The proposed plat for Lucky Lindy 2016 Addition, located within Section 21, Township 18 North, Range 1 East, Seward Meridian, Alaska is consistent with AS 29.40.070 *Platting Regulations* and MSB 43.15.025 *Abbreviated Plats*. Legal and physical access is provided to the proposed lots, consistent with MSB 43.20.100(A) Access Required. Frontage for the subdivision lots exists pursuant to MSB 43.20.320 Frontage. A soils report was submitted stating each lot has a minimum of 10,000 sq. ft. contiguous useable septic and 10,000 sq. ft. of useable building area pursuant to MSB 43.20.281 *Area*.

Re: **Useable Area Report**
Lots 5 and 6, Lucky Lindy Subdivision,
Located within Section 21, T18N, R1E, S.M., AK
AK Rim File No. 1600576

Attached is a Request for Comments for Lucky Lindy 2016 Addition, MSB Case # 2016-131, Tech CS. Also, attached is the vicinity map, soils report, owner's statement and preliminary plat with topo and drainage.

PRELIMINARY PLAT

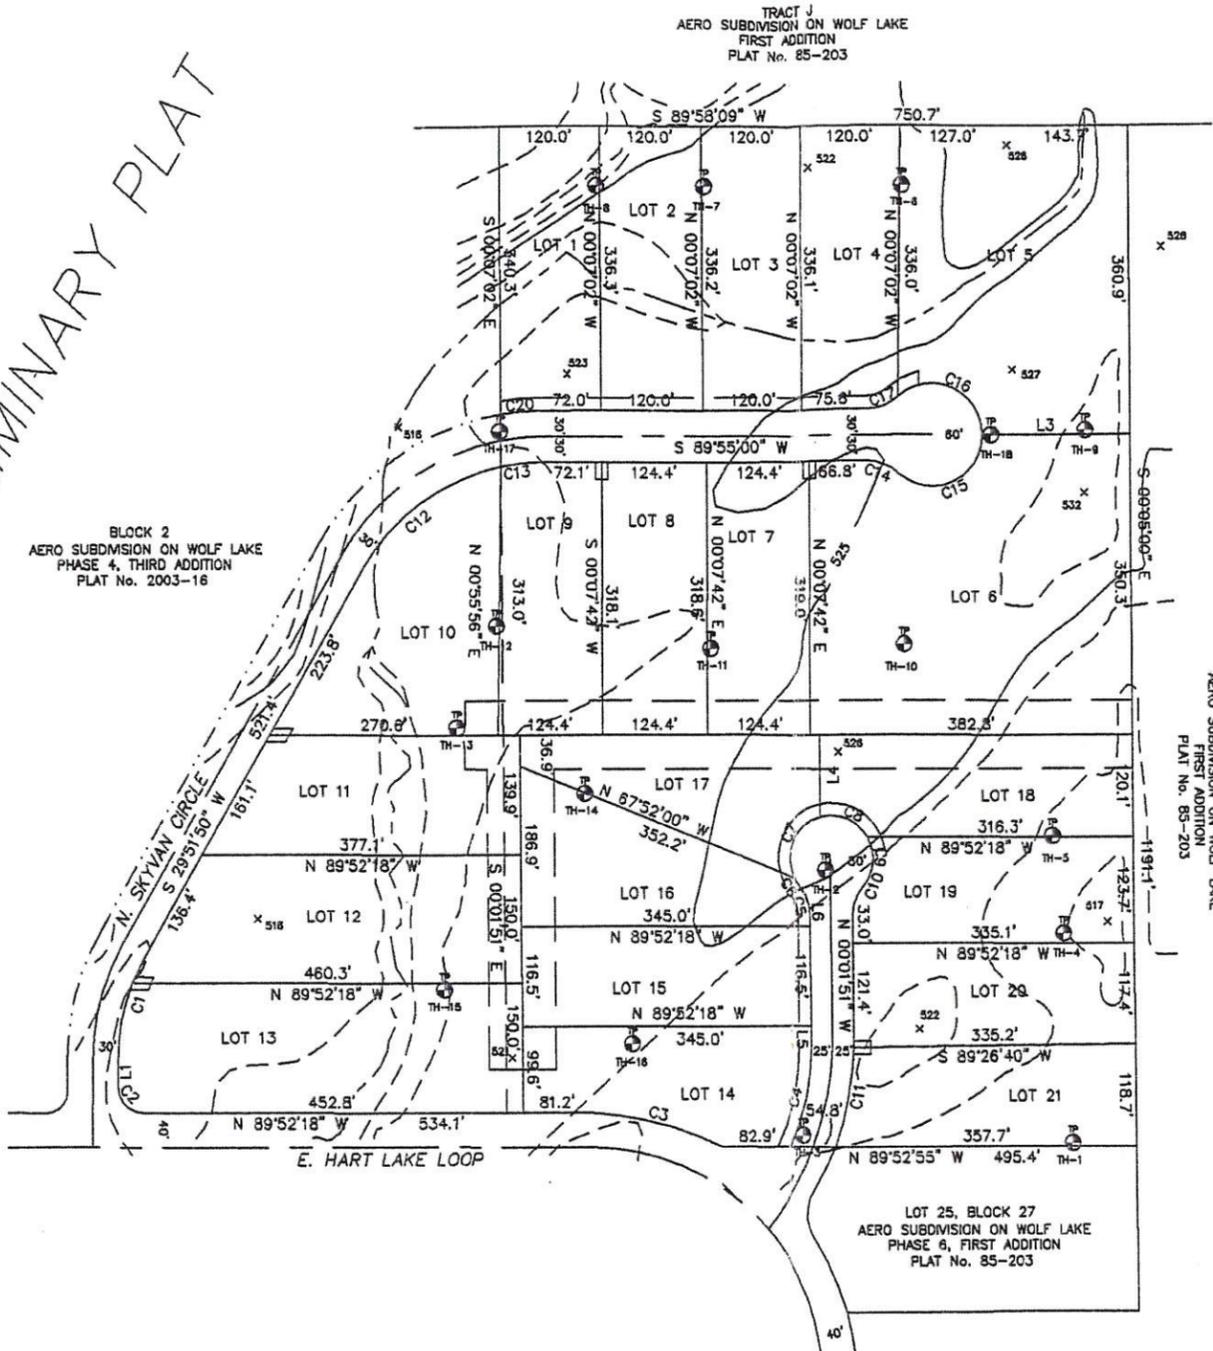
MTA request a 15 foot wide utility easement adjoining Skyvan Circle.

In summary, I oppose the proposed further division of the Lucky Lindy lots from previously platted due to unaddressed issues of drainage, access to runway, adequate home sites per lot, well site and septic system separation issues, and overall relationship with the longstanding existing airpark community.

I double checked the building and septic areas based on the CC&R's and still find that there is the required building and septic areas per MSB requirement of 10,000 sq. ft. of usable building area and 10,000 sq. ft. of usable septic area on each of the lots.
